Product Update: Moisture in Headlight

Product Update: Moisture in Headlights

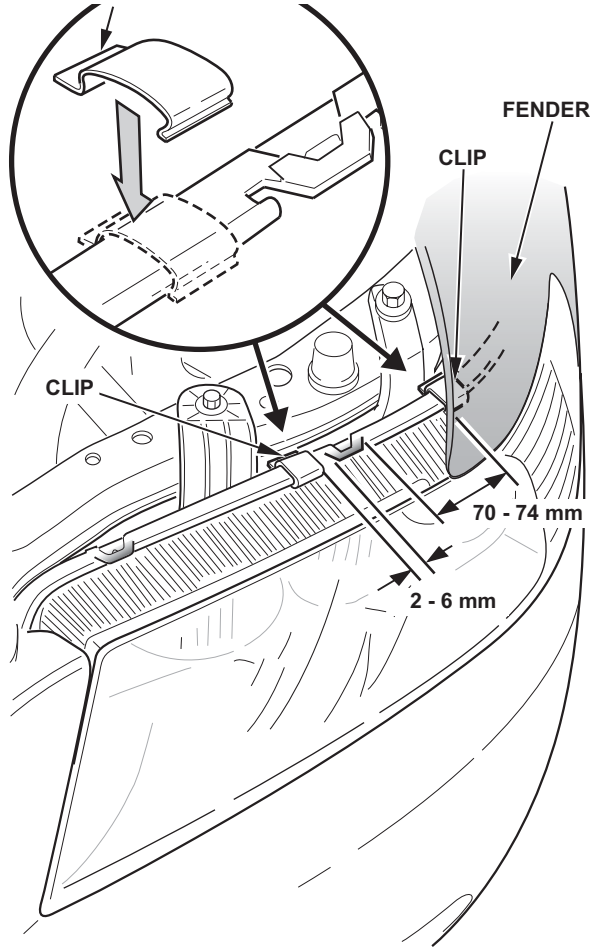
1. Remove the fender trim (see step 2 of REPAIR PROCEDURE A: REPLACE HEADLIGHT UNIT).
2. Attach two metal clips (four total) to each headlight unit as shown:

NOTE: Make sure the clips are properly attached in the proper direction.

"Tail" of the clip should point to the rear of the vehicle.

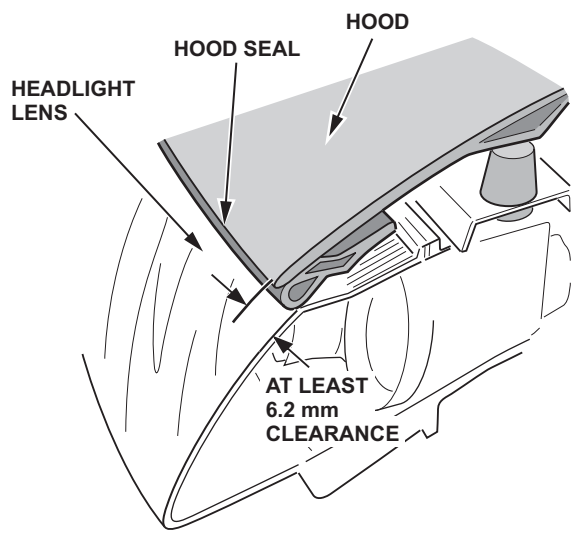
3. Make sure the hood is flush with the front fender and has at least 6.2 mm of clearance from the top of the hood to the top of the headlight. If needed, adjust the hood:

- Refer to page 20-134 of the service manual, or
- Online, enter keyword **HOOD** and select **Hood Adjustment** from the list.
